ECE/TRANS/WP.29/2009/5
18 December 2008

Proposal for Supplement 2 to the 11 series of Regulation No. 13
(Brakes of heavy vehicles)

Submitted by the Working Party on Brakes and Running Gear */

FIGURE 1A

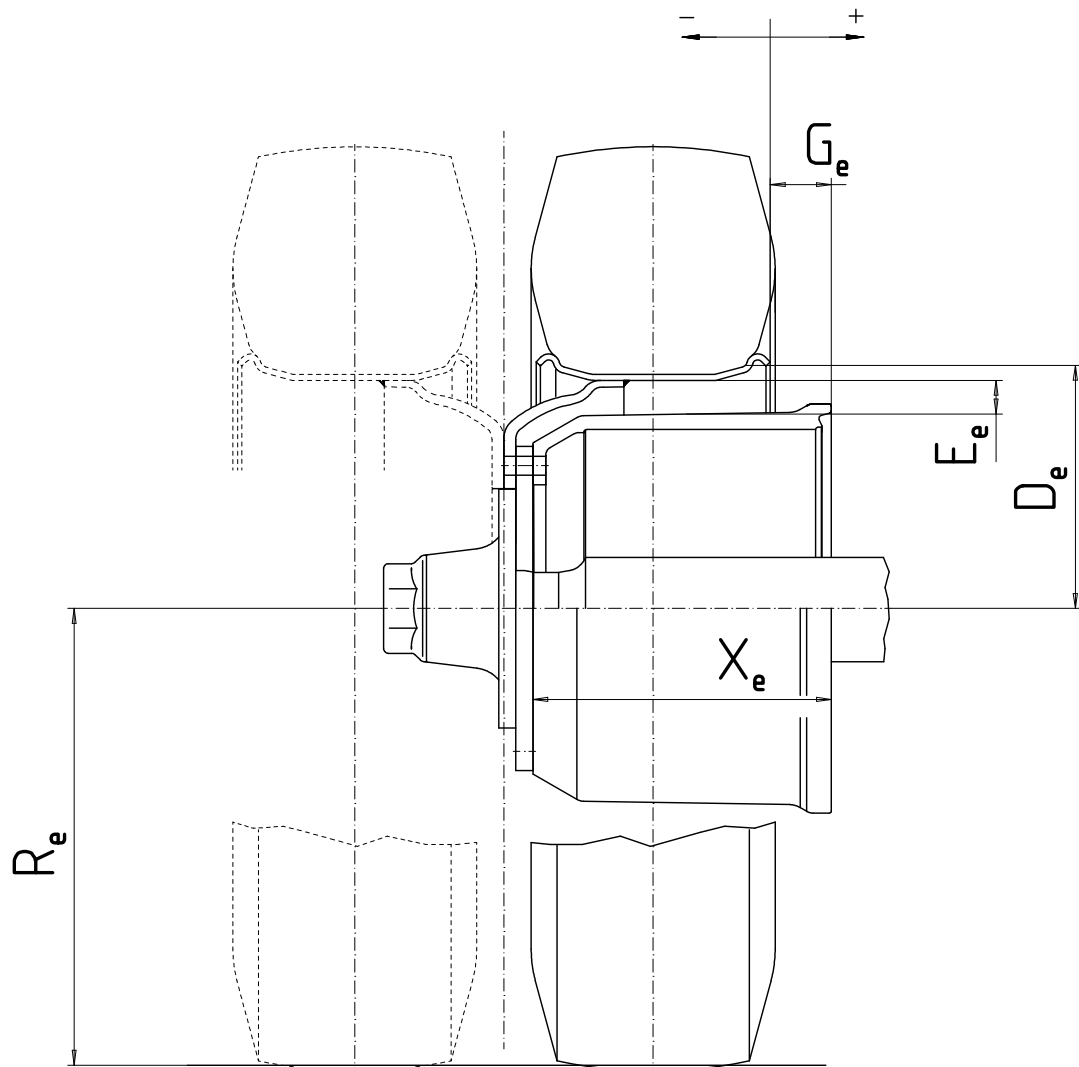
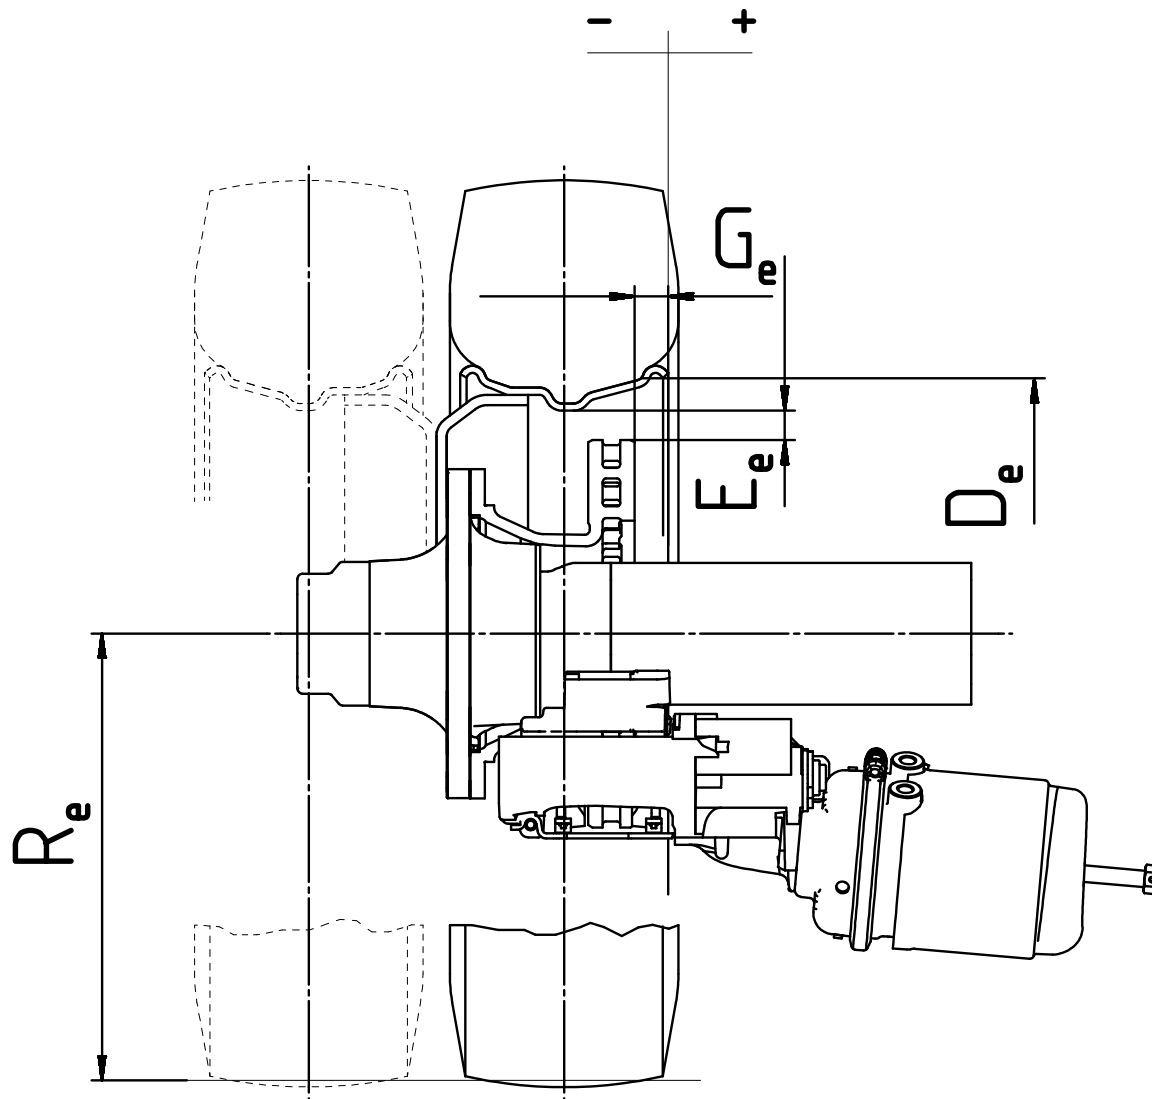
Add a new Appendix 5 to Annex 11, to read:

2. AXLE DATA
- 2.1. Manufacturer (name and address):
- 2.2. Type/variant:
- 2.3. Axle identifier: ID1-
- 2.4. Test axle load (F_e): daN
- 2.5. Wheel and brake data according to the following figures 1A and 1B

FIGURE 2A

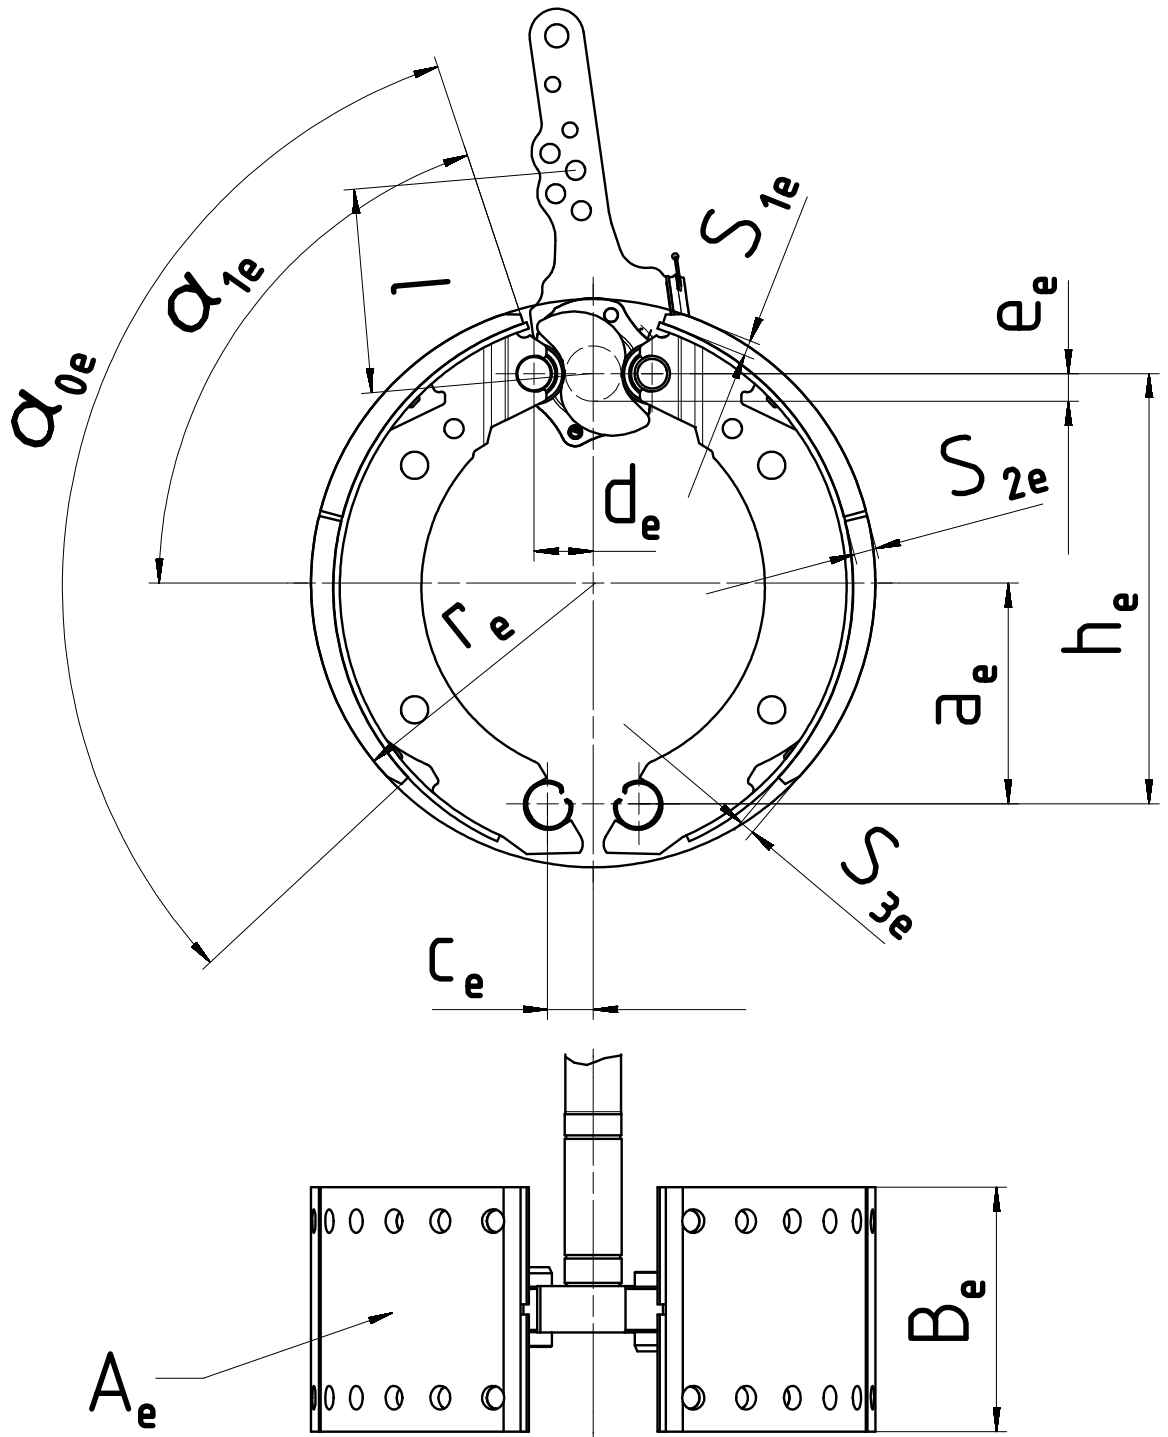
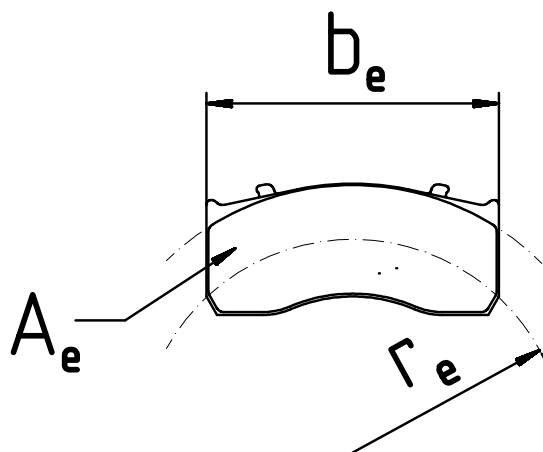
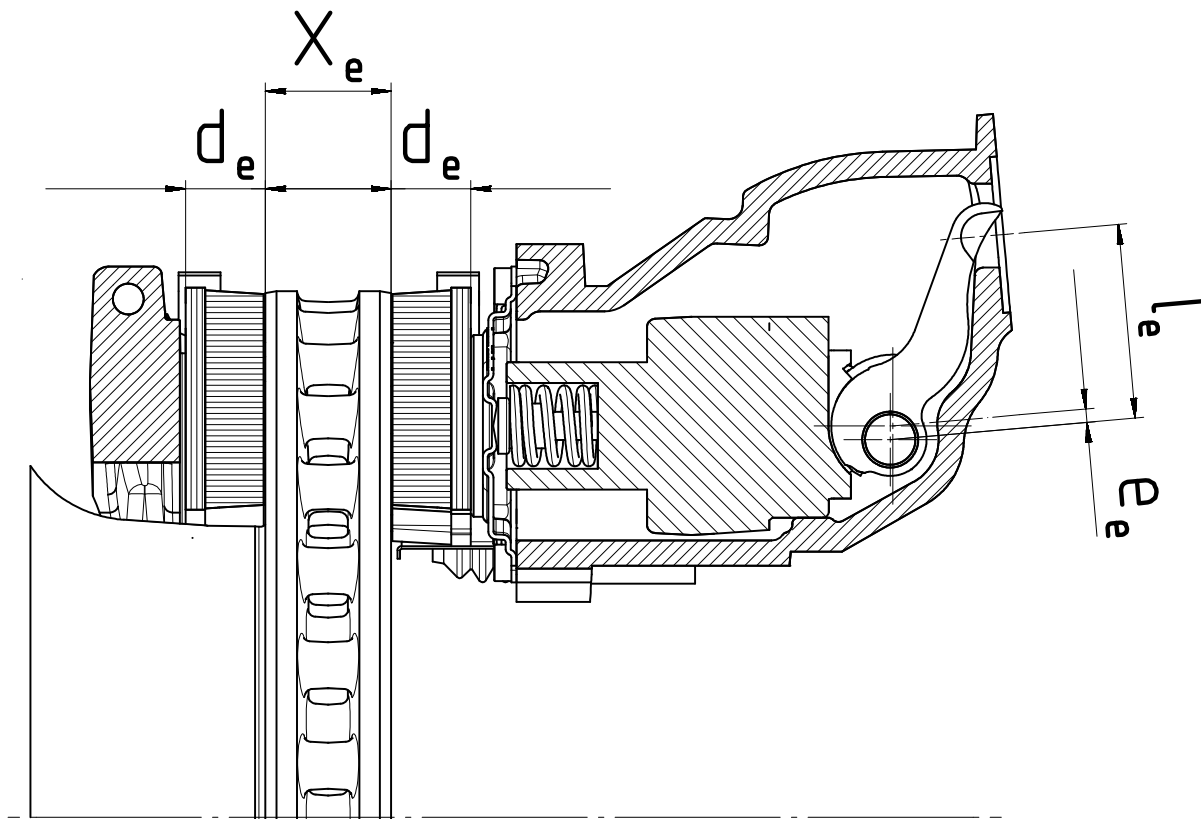
Annex 11 – Appendix 3, amend to read (including the deletion of figures 1A, 1B, 2A and 2B):

- 3. BRAKE
- 3.1. General information
- 3.1.1. Make:
- 3.1.2. Manufacturer (name and address):
- 3.1.3. Type of brake (e.g. drum / disc):
- 3.1.3.1. Variant (e.g. S-cam, single wedge etc.):
- 3.1.4. Brake identifier: ID2-
- 3.1.5. Brake data according to the following figures 2A and 2B:
